Access Compliance Report

Public Rights-of-Way

(Curb Ramps)

Intersection ID: 14236	Main Street: LEAKE_ST	Cross Street: NOBLES_AV	Location: SE
ADA ID: 6B3B5B2CFBEC	Ramp Type: PerpDiag	Initial Pass/Fail: Fail	Overall Compliance: No
Severity Score: 13.75			
Codes/Mitigation Info/Possible Solution		Field Measurements/Component Compliance

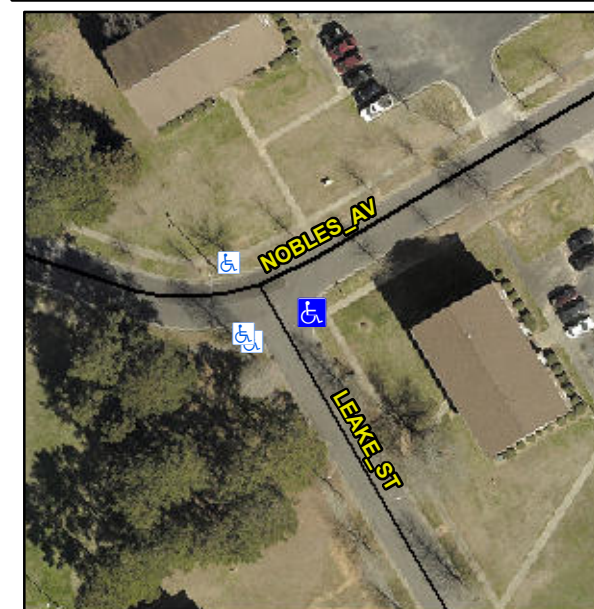
Not Found, R304.2.2, R304.5.3

Compliance	Description	Data	Compliance	Description	Data
N/A	Ramp Length (in)	86.0	No	Ramp Slope (%)	9.2
Yes	Ramp Width (in)	48.0	No	Ramp XSlope (%)	3.7
N/A	Flare Type LT	N/A	N/A	Flare Type RT	N/A
N/A	Flare Slope LT (%)	N/A	N/A	Flare Slope RT (%)	N/A
N/A	Flare Traversable LT?	N/A	N/A	Flare Traversable RT?	N/A
N/A	Landing Length (in)	N/A	N/A	DWS Provided?	N/A
N/A	Landing Width (in)	N/A	N/A	DWS Contrast?	N/A
N/A	Landing Slope (%)	N/A	N/A	DWS Length (in)	N/A
N/A	Landing X Slope (%)	N/A	N/A	DWS Full Width?	N/A
N/A	Landing Curb? (Y/N)	N/A	N/A	DWS Offset (in)	N/A
N/A	Shared Landing?	N/A			
N/A	Gutter Ponding?	N/A	N/A	Gutter Slope (%)	N/A
N/A	Gutter Lip Ht (in)	N/A	N/A	Gutter X Slope (%)	N/A
N/A	Painted X Walk1?	No	N/A	Painted X Walk2?	No
	X Walk 1 Direction	To N		X Walk 2 Direction	To W
N/A	X Walk 1 Width (in)	N/A	N/A	X Walk 2 Width (in)	N/A
	X Walk 1 Slope (%)	0.8		X Walk 2 Slope (%)	3.8
	X Walk 1 X Slope (%)	2.9		X Walk 2 X Slope (%)	3.1

N/A	Ramp inside XWalk1?	N/A	N/A	Ramp inside XWalk2?	N/A
	Road Slope (%)	2.7	N/A	Clear Space?	N/A
	Road X Slope (%)	1.7	N/A	Clear Space to XWalk (in)	N/A
N/A	Any Obstructions?	N/A	N/A	Storm Grate/Utility Hazard?	N/A
	Obstruction Type			Storm Grate/Utility Type	
		N/A			N/A
		Yes		Surface Condition? (G/P)	Good

Remove & Replace Curb Ramp With Two New Directional Ramps or Equivalent.
